Town of Hilton Head Island  
**Design Review Board Meeting**  
**Tuesday, May 11, 2021 – 1:15 p.m.**  
**AGENDA**

i. Wei Food Hall Facades, DRB-001076-2021

**PROJECT: Wei Food Hall Facades**

## DESIGN TEAM/DRB COMMENT SHEET

Landscape Plan  
**PORT ROYAL PLAZA**  
**95 MATHEWS DR.**  
 Hilton Head Island, South Carolina

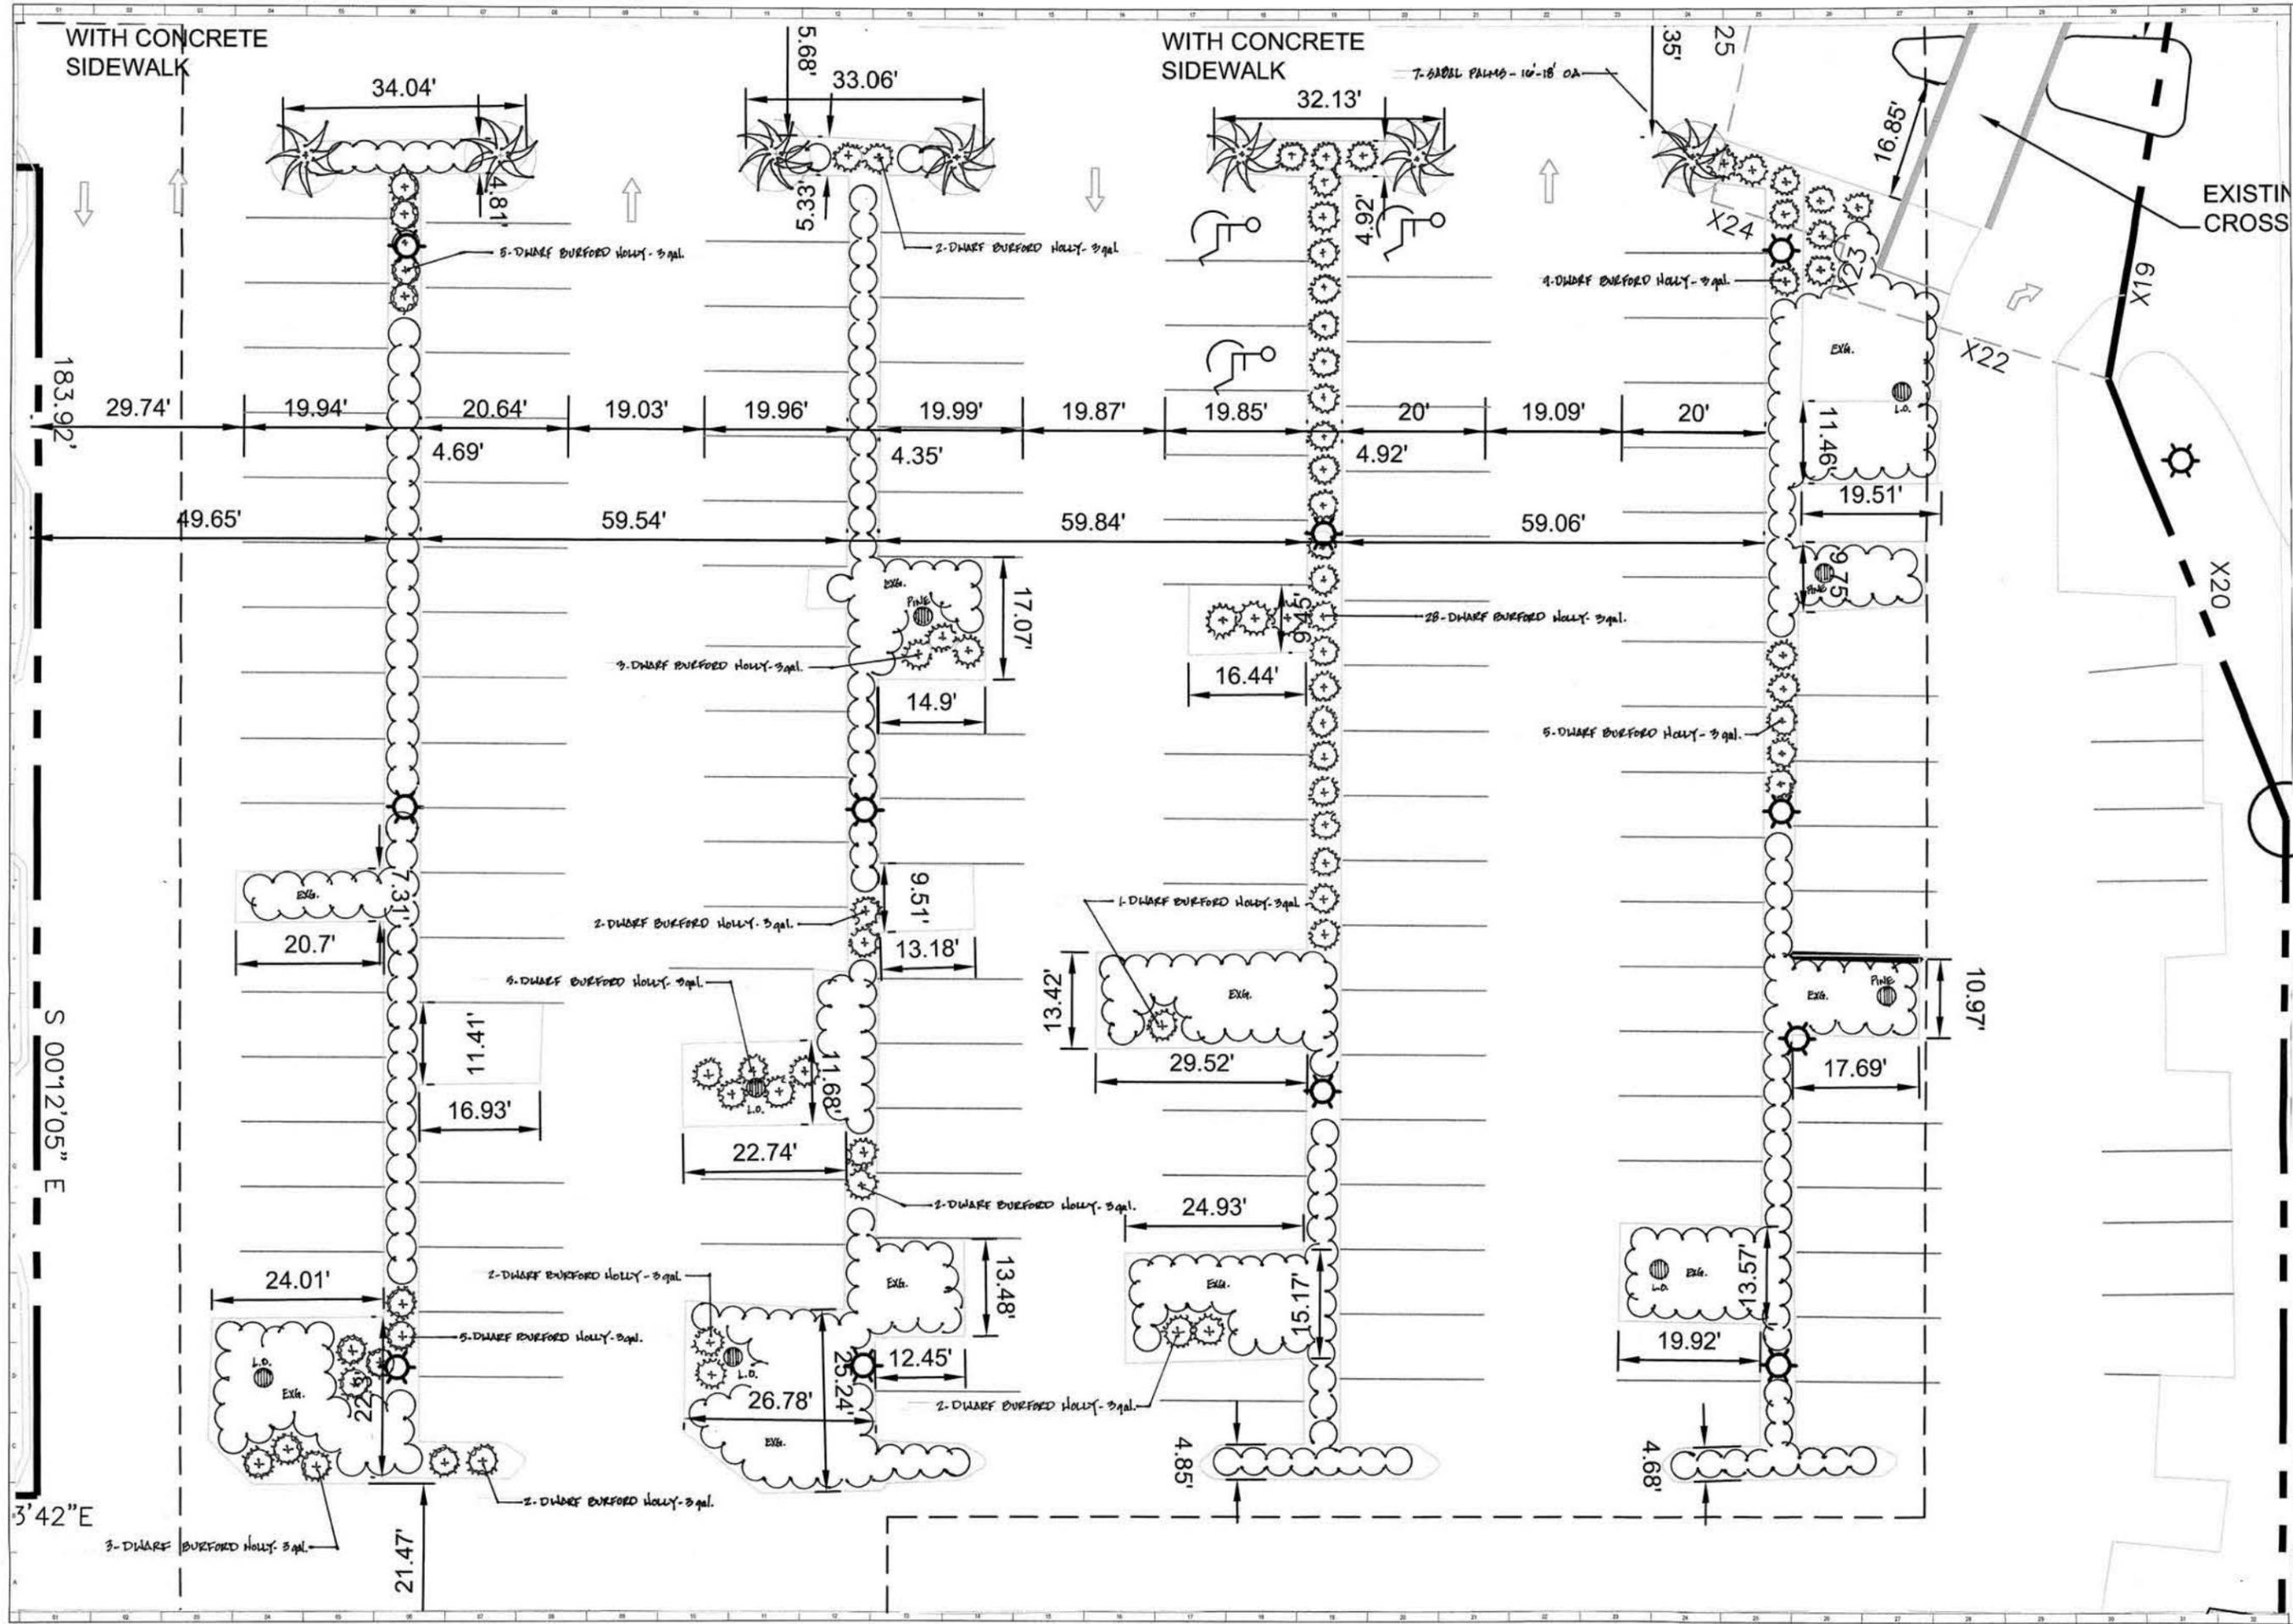
1. Provide Site Plan for review by Staff that address the following:
  - a. Dimensions of the proposed changes to the drive aisle and landscape area addition.

- b. Reconsideration of the pedestrian access through the new landscape area.
  - c. Specify / label the curb or other protection of the landscape area on the plans.

2. Revision of the Planting Plan for review by Staff that address the following:
  - a. Add additional (palms, hollies, etc.) to the landscape area between the building and the drive aisle.

- b. Planting appears thin between the building and the drive aisle.
  - c. Add taller plants along wall behind existing gazebo to break up the expanse of the wall.

3. Provide an updated site plan for review and approval by Town Staff and one DRB landscape architect
4. Within the beds at the front of the planet fitness building, the muhly grass and loropetalum shall be substituted with low evergreen shrubs.

5. The plantings along the eastern side of the building include a 4” caliper live oak on the corner
6. The two live oaks on the eastern side within the parking lot islands be increased to 4” caliper

7. Remove the Bradford pears and replace with sabal palmettos to match those that are being installed at the front of the building. The spacing and location of those shall be reviewed and approved by Town Staff and one DRB landscape architect.

8. The new plantings within the planting aisles shall maintain a 3’ clear area around the parking spaces.
9. Provide plant sizes in the planting schedule.

10. Replace jack frost Ligustrum with another more adaptive evergreen shrub.
11. Replace the wax myrtles in the parking lot with a dwarf variety shrub.
12. Provide site and architectural plans of what the eastern side will look like with and without a tenant.

**ENLARGED PLAN & DETAILS**

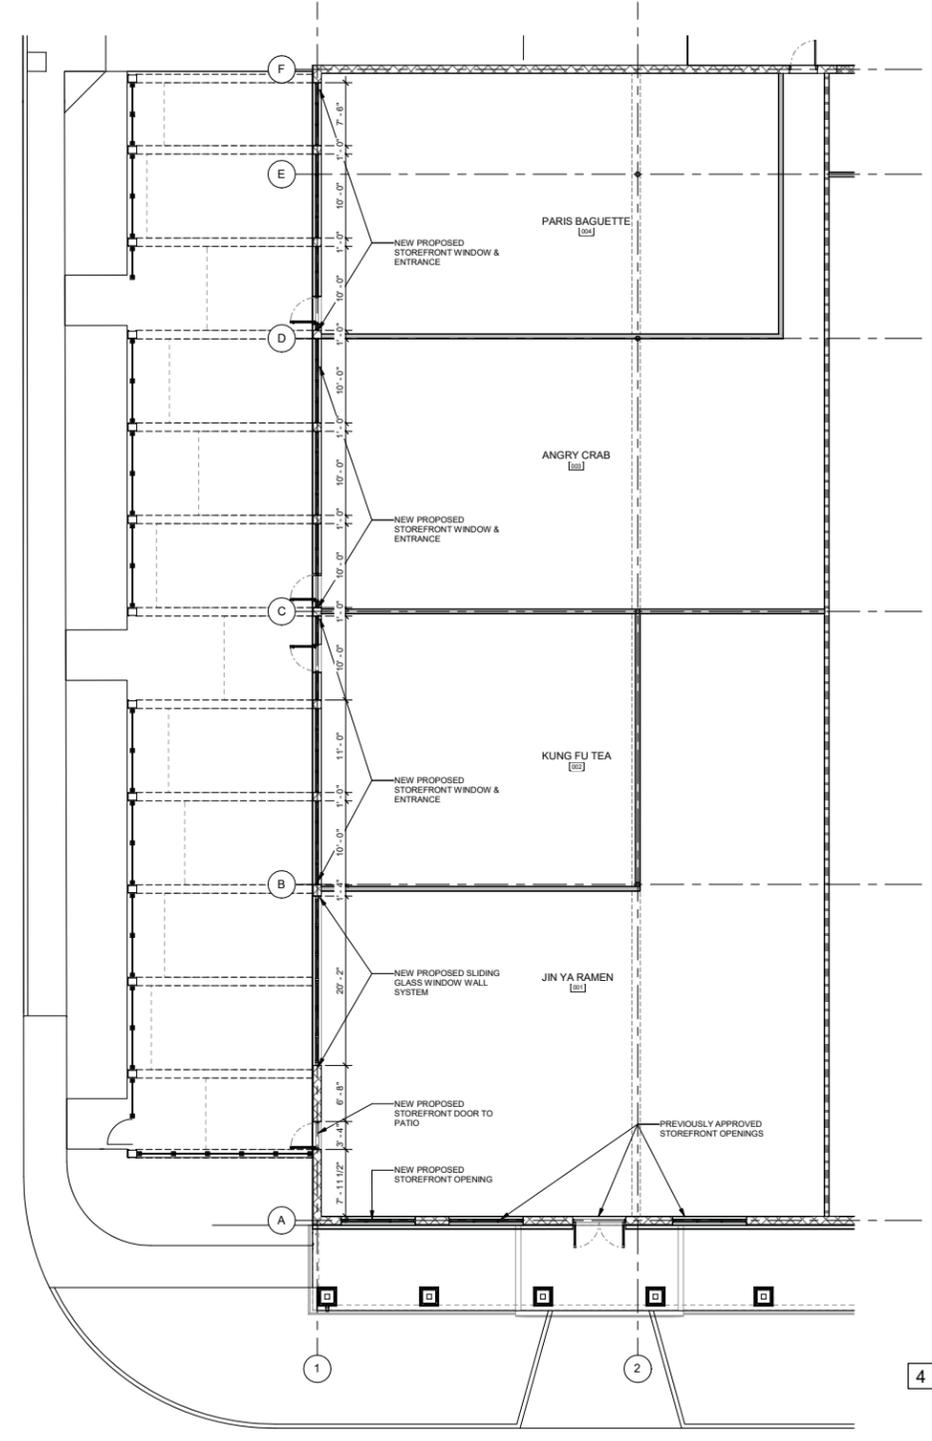
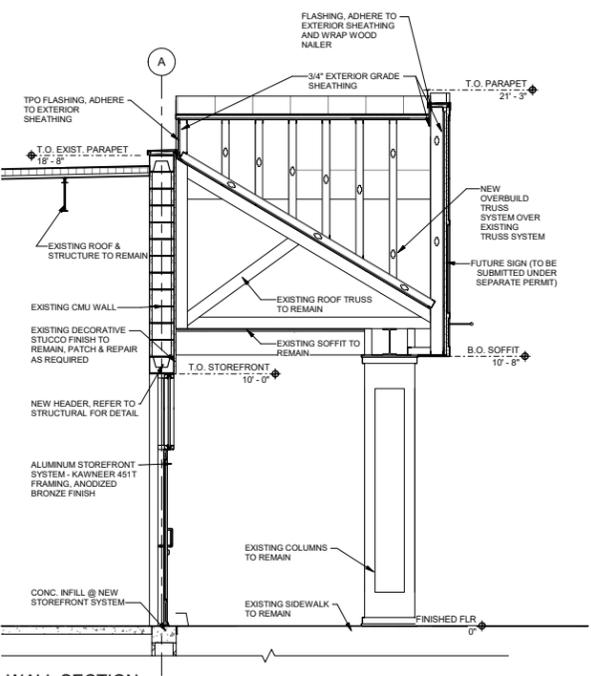
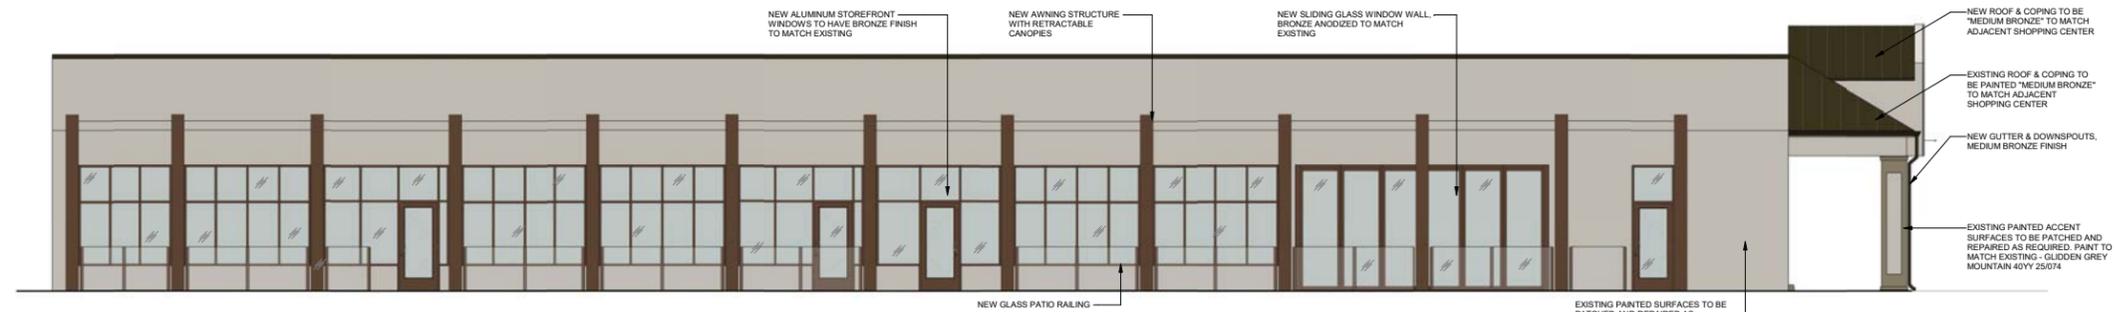
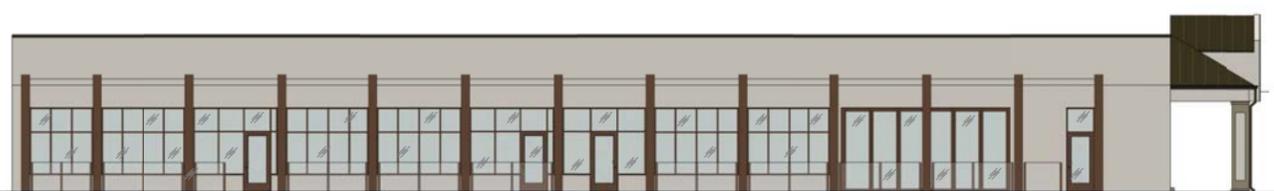
1. Provide a dimensioned Site Plan.
2. Provide physical color samples for the awning structure.
3. Revise the landscape plan to add trees.

<b><i>APPLICATION MATERIAL</i></b>				
<b>DRB REQUIREMENTS</b>	<b>Complies Yes</b>	<b>No</b>	<b>Not Applicable</b>	<b>Comments or Conditions</b>
Dimensioned Details and of Sections	<input type="checkbox"/>	<input checked="" type="checkbox"/>	<input type="checkbox"/>	Provide dimensioned site plan so the length and width of site elements (sidewalk and planting areas) is clearly shown.

<b><i>ARCHITECTURAL DESIGN</i></b>				
<b>DESIGN GUIDE/LMO CRITERIA</b>	<b>Complies Yes</b>	<b>No</b>	<b>Not Applicable</b>	<b>Comments or Conditions</b>
Utilizes natural materials and colors	<input type="checkbox"/>	<input checked="" type="checkbox"/>	<input type="checkbox"/>	<ol style="list-style-type: none"> <li>1. Color of the awning structure is not specified. Provide physical sample.</li> <li>2. Color of the awning is not specified. Provide physical sample.</li> </ol>
